Commonwealth Edison

Subject: Byron Station Units 1 and 2
Braidwood Station Units 1 and 2
Charging Pump Miniflow Lines
NRC Docket Nos. 50-454, 50-455,
50-456 and 50-457

Byron and Braidwood Stations
Charging Pump Miniflow Lines
Design Modification

RCS HOT LEG PRESSURE TRANSMITTERS

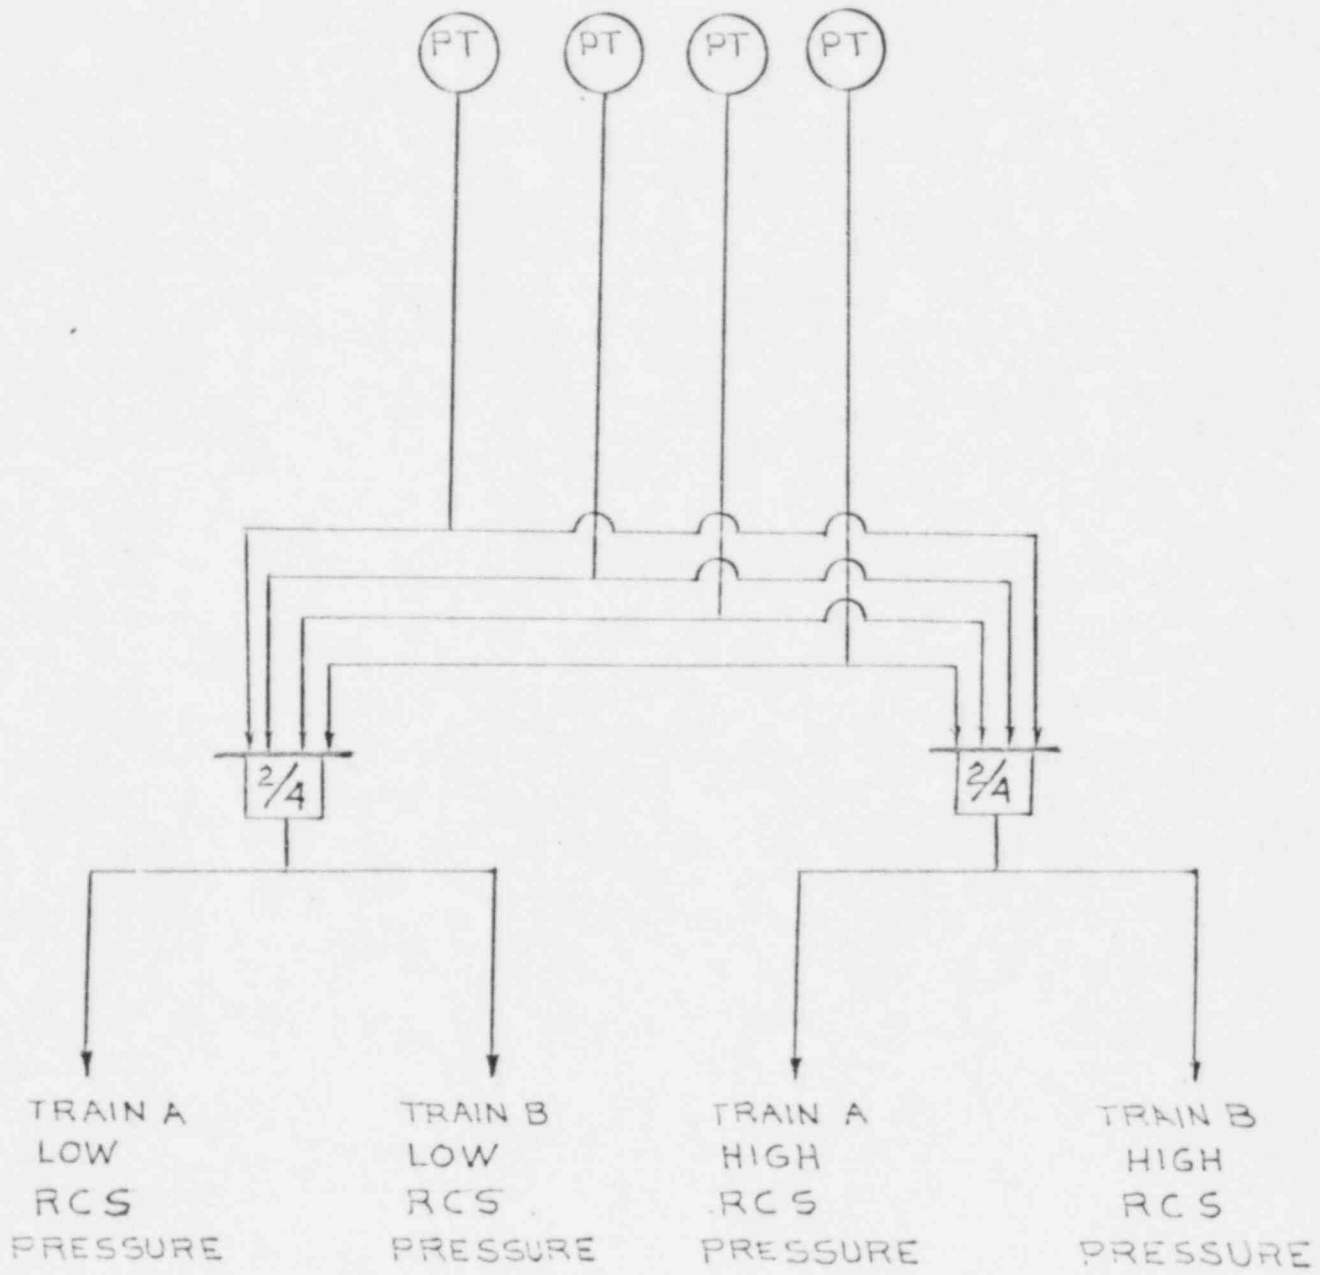
The centrifugal charging pumps can be protected under the conditions described in Section I by removing the safety injection closure signal from the pump miniflow valves 8110 and 8111. The concept to be evaluated utilizes an RCS pressure signal to automatically open and close the miniflow valves as required. Figures 1 and 2 will serve to illustrate the logic for operating the miniflow valves. RCS pressure signals will be available from four hot leg pressure transmitters to be supplied in the future. These four transmitter signals will be used to form redundant two-out-of-four high and low RCS pressure signals (Figure 1). Four instruments appear to be sufficient to satisfy the IEEE-279 requirements for on line test-ability and single failure.

FIGURE-2

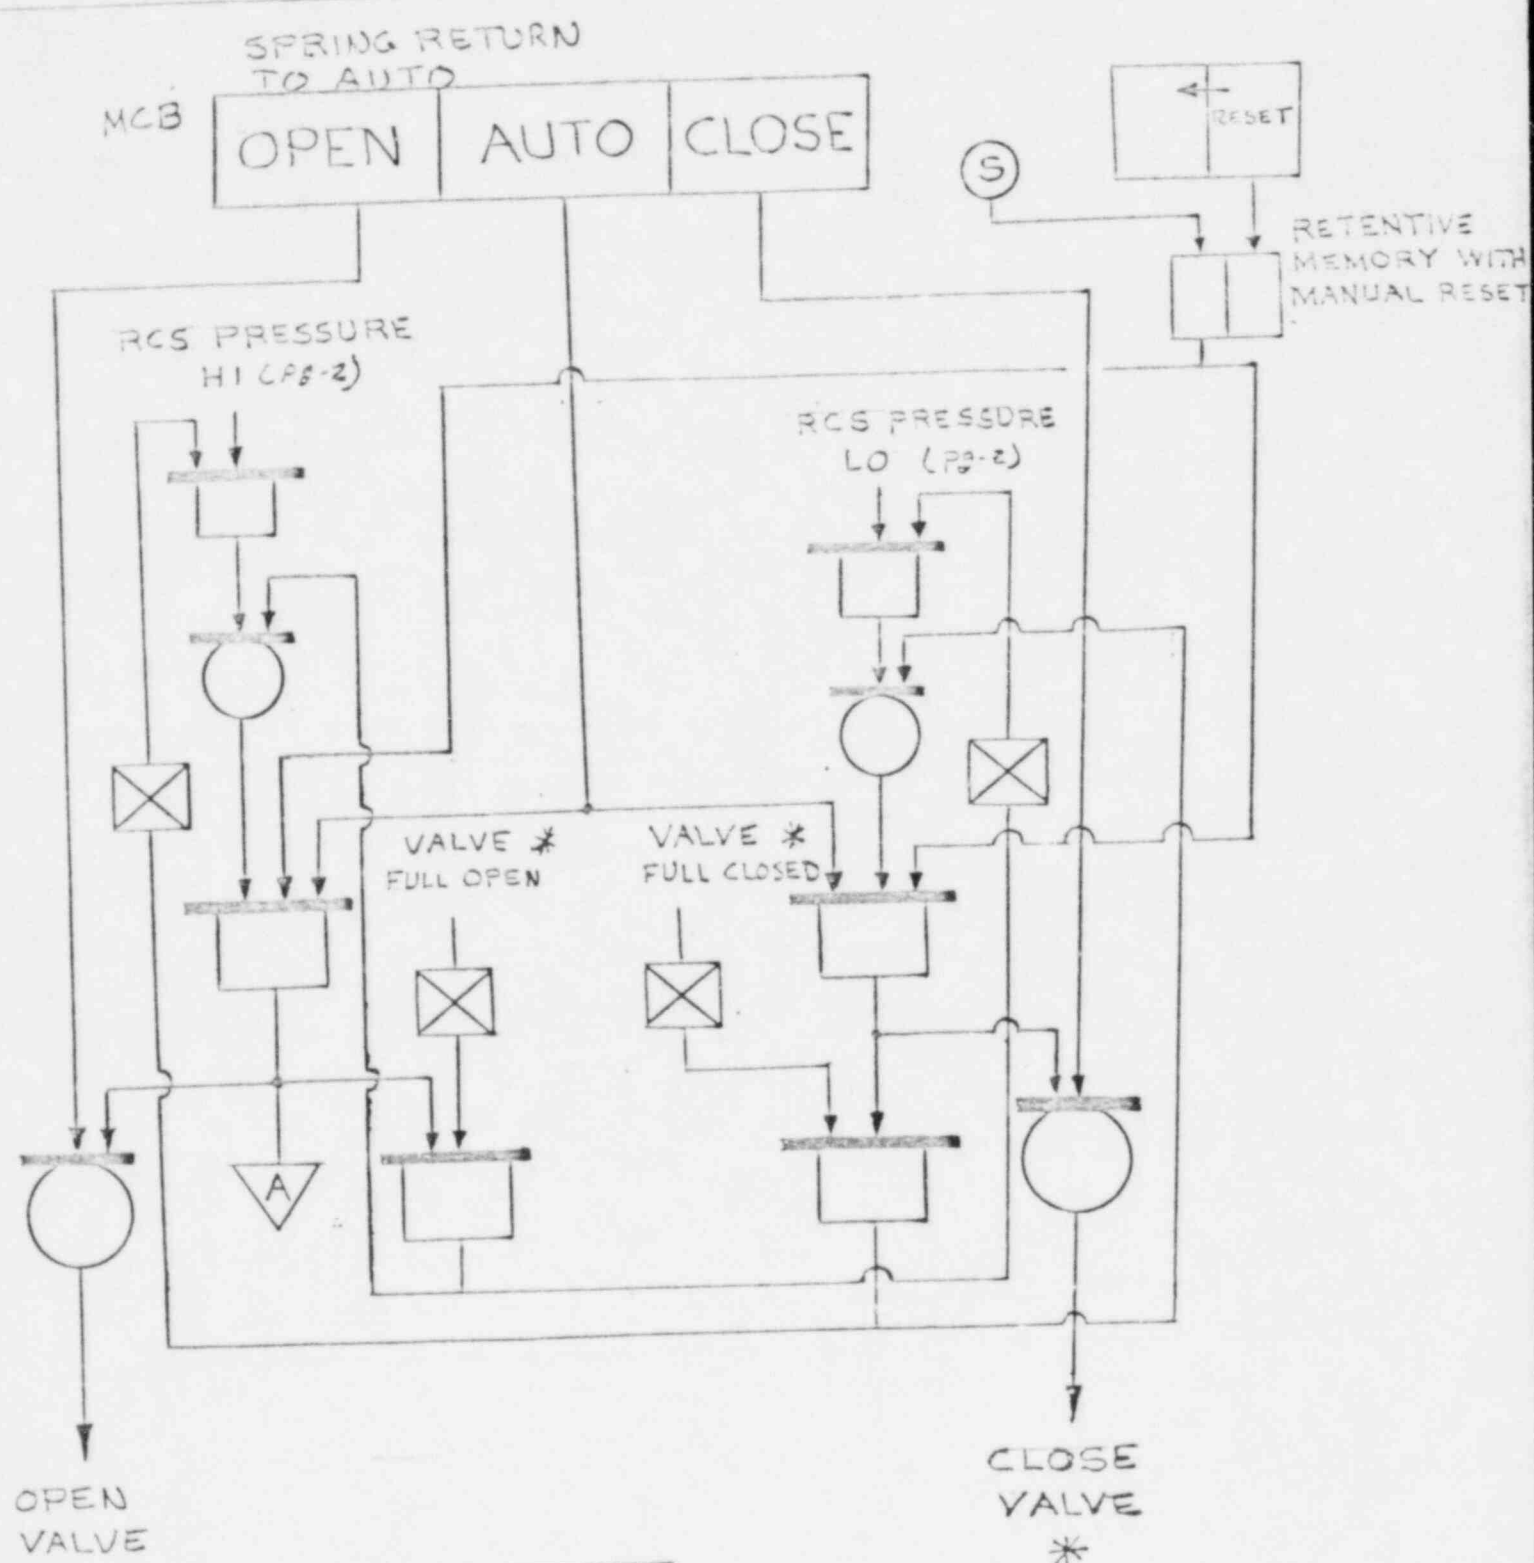
With the spring return valve control switch in auto, RCS pressure above a predetermined value will open the miniflow valves 8110/8111 and pressure below a second setpoint will close the miniflow valves (figure 2). It is considered necessary to provide the capability to open the miniflow valve as well as to close it because repressurization of the RCS may follow an initial depressurization for the accidents considered. Two distinct and separate open/close setpoints have been chosen as opposed to a single setpoint to minimize the possibility that an oscillating pressure signal for a given event might cycle the miniflow isolation valves repeatedly. In order to prevent the miniflow isolation valve from stopping and possibly reversing in mid-travel, provisions have been included in Figure 2 to ensure that a miniflow valve completes a closure cycle which may be in progress before it can be re-opened and vice-versa. This latch-in feature in-turn requires provisions to ensure that the valve does not receive conflicting signals simultaneously as could be the case if the pressure signal increases above the open setpoint during a latched in closure cycle. These features could be accommodated in the valve control circuit utilizing limit switch signals. These admittedly elaborate considerations are being included because we are using motor driven isolation valves for a control application which was not part of the original design and because the RCS pressure transient varies with the postulated break area.

Figure 2 also indicates that the RCS pressure signal will operate the miniflow valves only in the presence of a safety injection signal. Without the "S" signal permissive, the valves would be closed automatically on low RCS pressure during modes 4,5,6, and possibly mode 3. The inclusion of an "S" signal leads to a further requirement that in individual retentive memory with manual reset be provided for each miniflow valve. This satisfies the protection system requirement that equipment actuated by an "S" signal be individually latched such that the status remains unchanged if the "S" signal is removed. If the operator resets safety injection to take control of the transient, the miniflow valves will remain under automatic control until deliberate intentional action is taken to reset the retentive memory. These retentive memories do not necessarily have to be on the main control board, but they must be different than similar retentive memories used in the logic for sump valves 8811A/B because it is conceivable that the operator might want to reset the memories for 8110 and 8111 without defeating the ECCS sump valve logic.

If the positive displacement pump is operating, the centrifugal charging pump miniflow valves must be opened above an RCS cold leg pressure of 2018 psig to ensure at least 60 gpm from the weakest centrifugal charging pump, assuming both centrifugal charging pumps are operating.

The recommended closing setpoint is 1400 psig cold leg pressure.

FIGURE 3

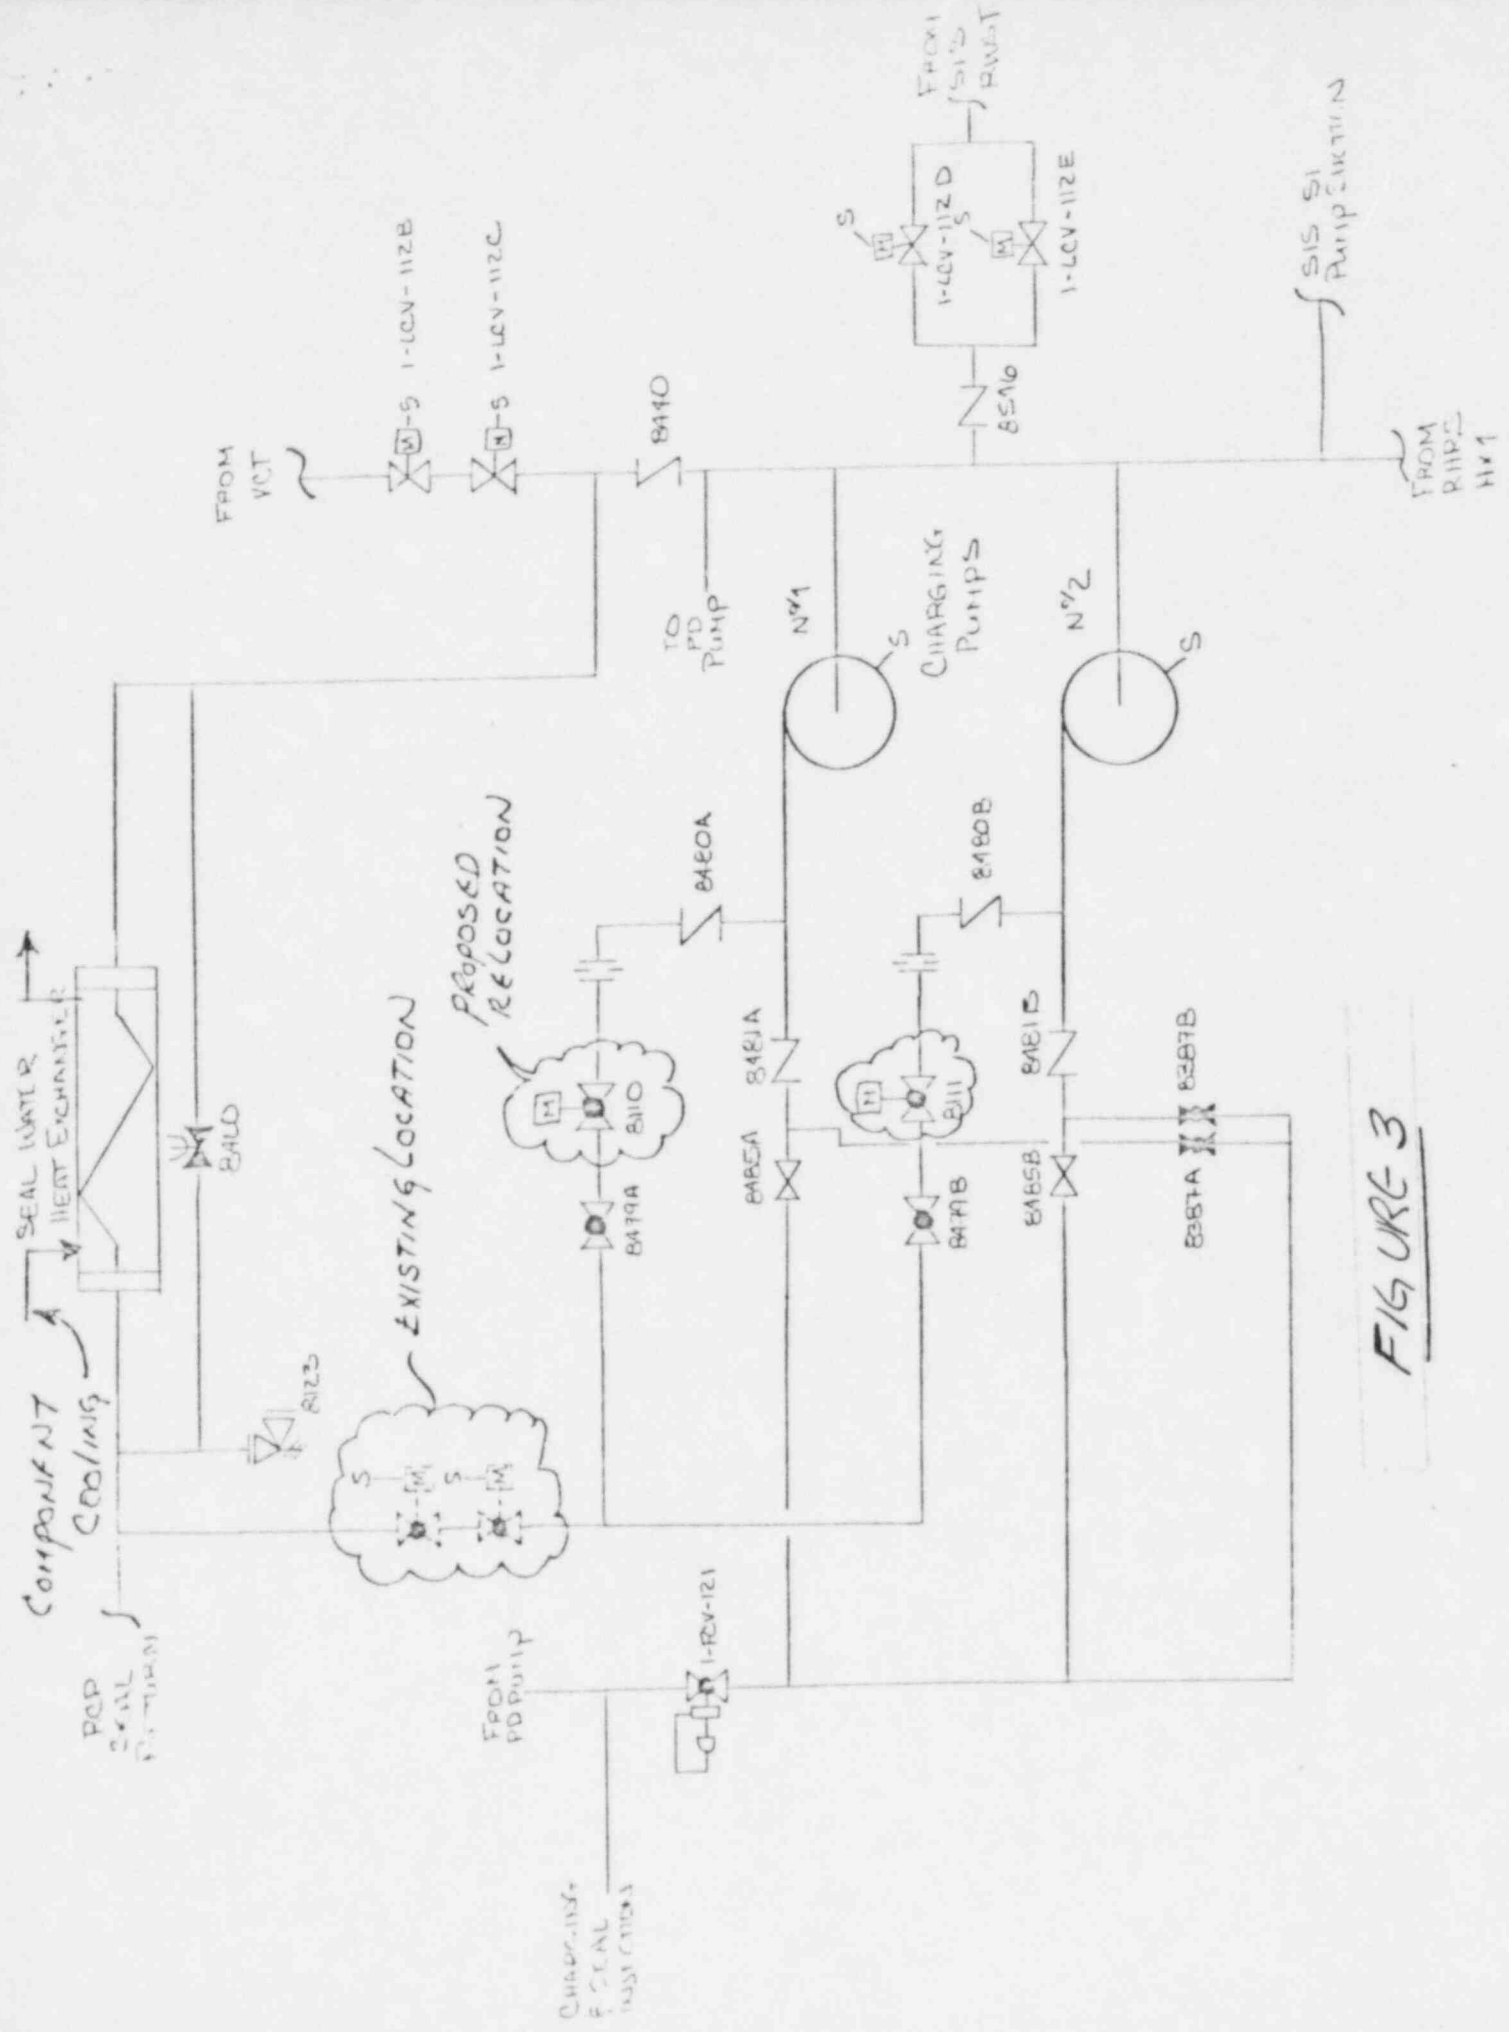
The existing miniflow arrangement (Figure 3) features miniflow isolation valves 8110 and 8111 in series in the common portion of the miniflow line. If either of these two valves fails to re-open upon an increasing RCS pressure transient, then both centrifugal charging pumps could be deadheaded. This problem can be circumvented by moving the valves to the individual portions of the miniflow lines as shown in Figure 3.
